## United States Patent and Trademark Office

APPLICATION NO.	FILING DATE	FIRST NAMED INVENTOR	ATTORNEY DOCKET NO.	CONFIRMATION NO		
10/083,079	02/26/2002	Dominik Schutz	TRW(ASG)6052	4699		
26294	7590 11/01/2004		EXAMINER			
TAROLLI, SUNDHEIM, COVELL & TUMMINO L.L.P. 526 SUPERIOR AVENUE, SUITE 1111 CLEVEVLAND, OH 44114			LUONG, VINH			
			ART UNIT	PAPER NUMBER		
	,		3682			
			DATE MAILED: 11/01/2004

`, ',		Application	on No.	Applicant(s)			
Office Action Summary		10/083,07	<b>'</b> 9	SCHUTZ, DOMINIK	2		
		Examiner		Art Unit			
		Vinh T Luc	ong	3682			
Period fe	The MAILING DATE of this communic or Reply	cation appears on the	cover sheet with the co	rrespondence address -	P#		
A SH THE - Exte after - If the - If NC - Failt Any	ORTENED STATUTORY PERIOD FO MAILING DATE OF THIS COMMUNIO nsions of time may be available under the provisions of SIX (6) MONTHS from the mailing date of this communication of the provision of period for reply specified above is less than thirty 30 period for reply is specified above, the maximum stature to reply within the set or extended period for reply wreply received by the Office later than three months afted patent term adjustment. See 37 CFR 1.704(b)

## **ATTACHMENT # 1**

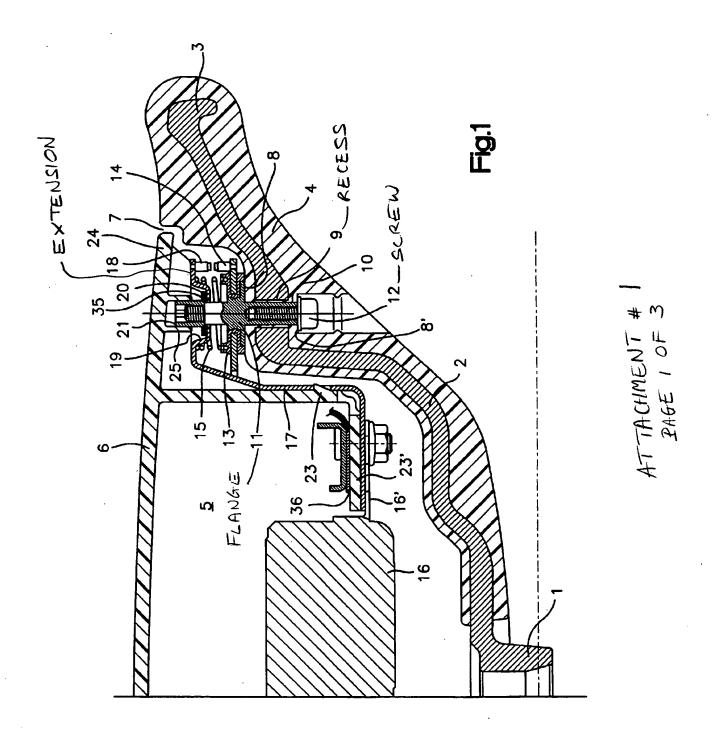
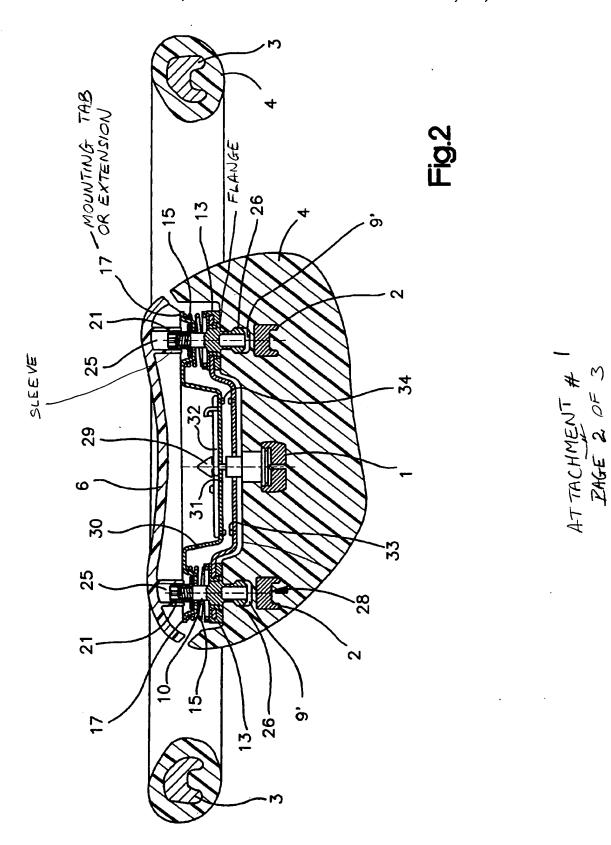
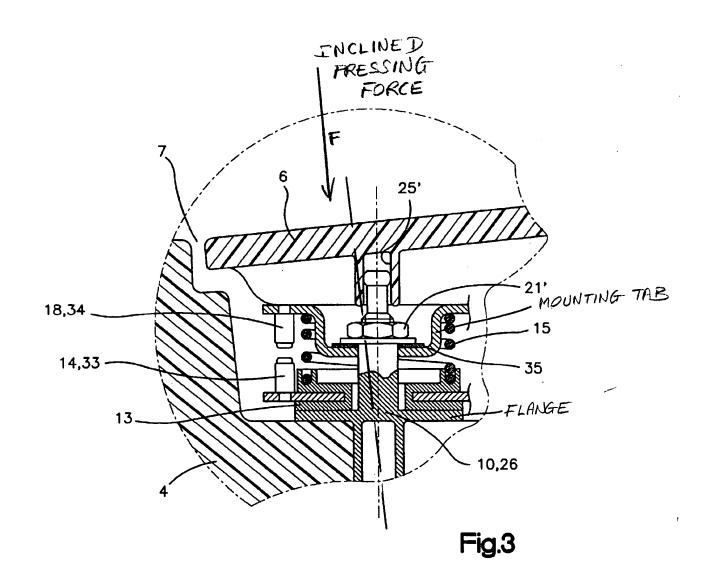
Regarding claim 3, said housing 17 is cup-shaped which is open towards said covering cap 6 and adapted to receive said gas bag 5, an edge of said receiving housing 17 has extensions 17 (Attachment # 1) projecting laterally outwards and towards said edge of said covering cap 6, said guides 10 or 10, 26 are provided on said extensions 17.

Regarding claim 9, said guides 10 or 10, 26 are received in said covering cap 6 so as to inherently have no lateral play (Figs. 1-3).

Regarding claim 10, said module 5 has a front side and said covering cap 6 covers said module 5 entirely on said front side (Figs. 1 and 2).

Regarding claim 11, said guides 10 or 10, 26 are not directly connected with each other as seen in Fig. 2.

Fourth, Applicant contends that the bolt is still in a fixed axial direction and provides a fixed abutment for the mounting tab 17 to tilt about. However, Fig. 2 of Bohn shows that the guide 10 is projected out of the tab 17. Therefore, the guide 10 is tilted with the tab 17 as shown in Bohn's Fig. 2 and as Applicant admitted in the Amendment filed on July 30, 2003.

Fifth, Applicant asserts that Bohn, col. 3, lines 42-26, discloses that the tab 17 may be tilted, not the bolts. Nevertheless, since the bolt 10 is mounted on the tab as shown in Fig. 2 and described in col. 2, line 65 through col. 3, line 31, thus, when the tab 17 is tilted, the bolt is tilted therewith. In other words, Bohn implicitly describes that the bolts may be tilted with the tab. *In re Opprecht*, *supra*.

with the law of physics. In fact, Bohn's Fig. 3 shows that when Bohn's edge 24 of the covering cap 6 is depressed, the sleeve 25' will tilt and the bolt 10, 26 will be tilted therewith because the head of the bolt is within the sleeve 25'. Therefore, Bohn's blot is guided by Bohn's sleeve 25. In the same manner, Applicant's bolt 32 is guided by Applicant's sleeve as seen in Figs. 4a and 4b of Attachment # 2.

## **ATTACHMENT # 2**

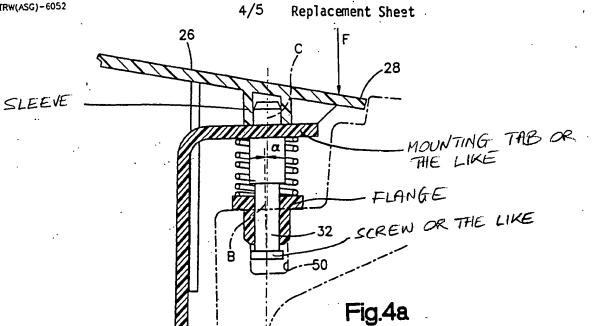
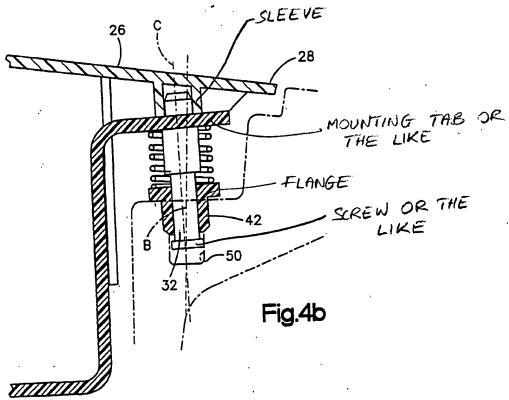
On the other hand, if a person of ordinary skill in the art would recognize that flange 11 and screw 12 of Bohn prevent tilting and axial movement of bolt 10 of Bohn as Applicant alleges, said person of ordinary skill would also recognize that Applicant's flange and screw (or the like as shown in Attachment # 2) prevent tilting and axial movement of Applicant's bolt 32.

Nevertheless, Applicant's bolts 32 are also provided with an extremely large area of contact and braced against movement by a screw or the like at their outermost ends as seen in Attachment # 2. Therefore, if one applies sufficient force on Bohn's cap 6 at the head areas of Bohn's bolts 10, the bolts 10 will move or tilt as admitted by Applicant in the Amendment filed on July 30, 2003. In other words, Bohn's casing is made of foamed material does necessarily imply that it is flexible enough so that the bolts 10 provided with an extremely large area of contact and braced against movement by a screw 12 will move a noticeable amount when force is transmitted to them by pressing on the covering cap 6 to actuate the horn. *In re King* and *In re Merk & Co., Inc., supra.*
